UNITED STATES PATENT AND TRADEMARK OFFICE

10/598,000

Office Action Summary	Application No. 10/598,000	Applicant(s) MIJIRITSKII ET AL.	
	Examiner GERARD T. HIGGINS	Art Unit 1794

DETAILED ACTION

With regard to claim 1, Sullivan et al. disclose the optical recording medium of Figure 1.

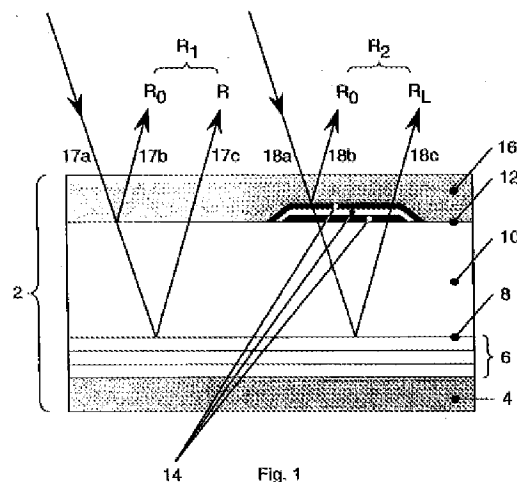
The device is comprised of a recording coating **6**, which reads on applicants' first data layer and a substrate **10** and a logo coating **14**, which together read on applicants' first transparent layer (col. 6, lines 4-21). The substrate **10** reads on applicants' first substrate and the logo coating **14** reads on applicants' first label layer. The protective

layer **4** reads on applicants' third substrate. The data in the recording coating is retrievable through the transparent layer as can be seen by the arrows in the Figure, and additionally as stated at col. 5, lines 6-45. The transparent layer comprises a label material **14** on the read-side of the disc. The label material can be deposited through a mask, a dielectric coating, or a photolithographically etched layer (col. 6, lines 10-21). The Examiner deems a photolithographically etched layer would comprise a layer "wherein the reflection or the absorption is affectable by illuminating the label material for the forming of the first label."

With regard to claim 2, the logo coating **14** is apart of the first transparent layer as explained above.

With regard to claim 14, the optional protective coating **16** reads on applicants' fourth substrate. It would have been obvious to place this protective coating on either of the first or second label layers for added protection of said label.
